**SPECIAL COUNCIL MEETING AGENDA**

#### **3.1 86-96 Gleadow Street, Invermay - Sports and recreation - gymnasium and fitness centre; change of use to part of property and associated signage**

**FILE NO:** DA0023/2015, SF2346

Project		Details			Drawing Title
	86-96 GLEADOW STREET, INVERMAY		DEVELOPMENT APPLICATION CHANGE OF USE			
	Revised 11 March, 2015	Drawn By THOMAS L BAIRD	Page 3 OF 6	Scale 1:200 @ A3		03 SITE PLAN

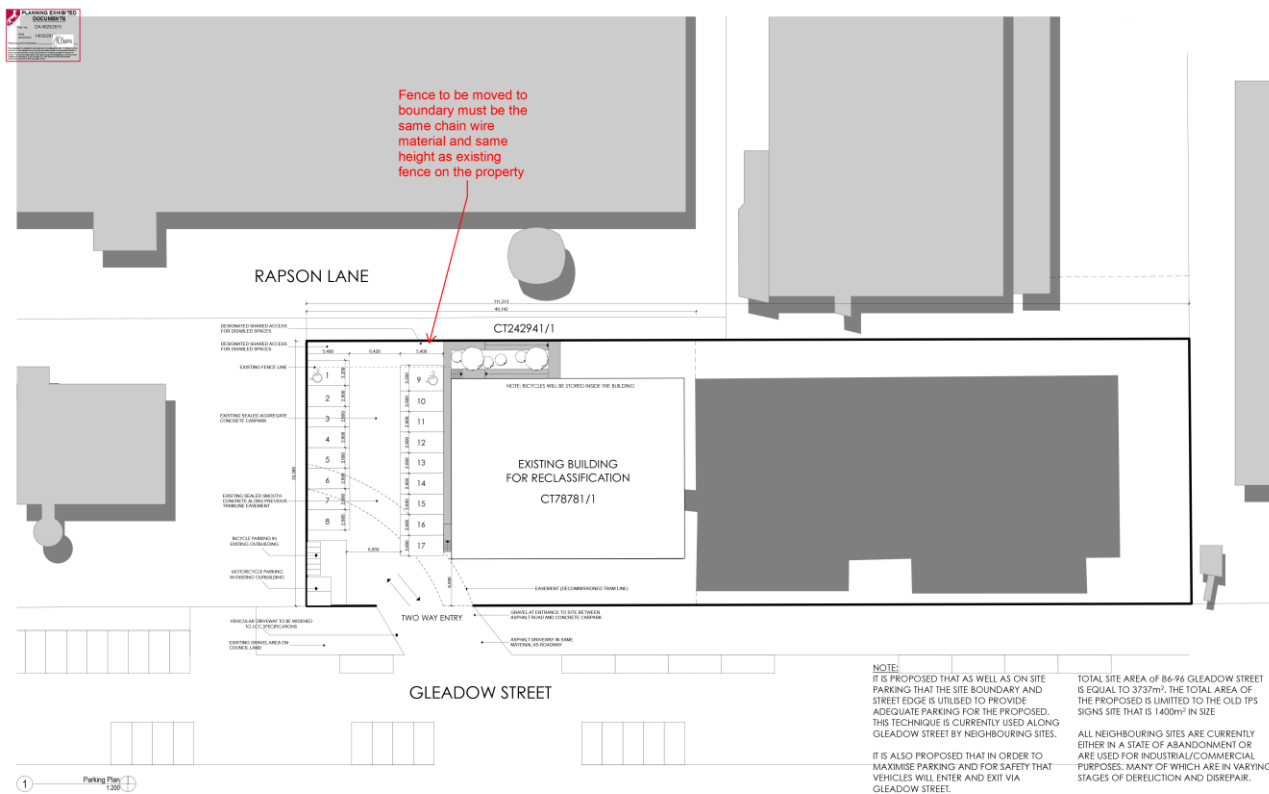
As the proposed car parking area would necessitate the removal of the rear fence, it is recommended that any new fencing is similar to what already exists e.g. wire fencing. This would ensure the impacts of fencing would be no more detrimental than what already exists (see marked up plans attached to the report).

Fence to be moved to boundary must be the same chain wire material and same height as existing fence on the property

- a. Construction of a new vehicular crossing and driveway located to be aligned with the aisle of the car park and the removal of the existing angled driveway;
- b. Parking bays designated as being for persons with a disability (accessible bays) are to comply with the dimensions set out in Australian Standard AS2890.6 2009;
- c. Relocation of the parking bays 9-17 to the north to maximise the width of the entry and exit lanes;
- d. Correct orientation of the wheelchair symbol within the accessible parking bays;
- e. Installation of the bollard and line marking associated with shared space for the accessible parking bays in accordance with the requirements of AS2890.6 2009.
